SIB 52 12 25 CLICKING NOISE FROM SEAT BACKREST

2025-09-17

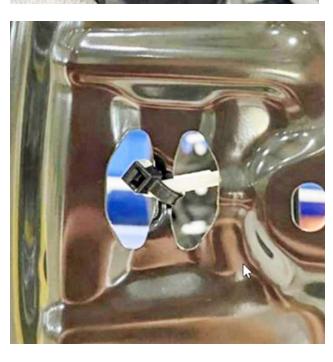
A clicking noise can be heard from one or both front seat backrests. This noise is heard when leaning against the backrest of the seat or while the vehicle is cornering.

The hooks for the back support mat mounting spring move against the seat backrest frame.

Apply 2 cable straps per seat to lock the spring hook(s) so they can't move relative to the seat backrest frame. The cable straps are only required in the two locations circled in red.

Secure the fastening spring hooks of the flex mat to the seat backrest frame utilizing cable straps (2 per seat)
